**1958 Agreement – Consideration of draft amendments
to existing Regulations submitted by GRSG**

Proposal for the 07 series of amendments to Regulation No. 107 (General construction of buses and coaches)

Submitted by the Working Party on General Safety Provisions*

Figure 10
Distances for test fire No. 2

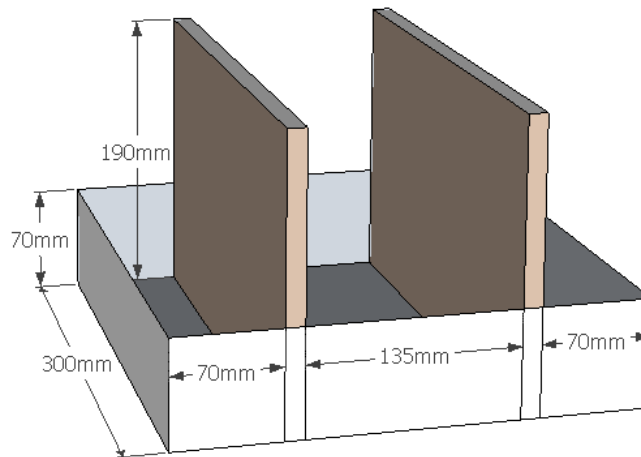
1.10.2. The square pool fire trays with fibreboards and the rectangular pool fire trays shall be positioned in its orientation according to the test scenarios in Appendices 2 to 4. Figure 10 shows the dimensions for test fire No. 2. The test fire shall be positioned perpendicular to the long edge of the test apparatus.
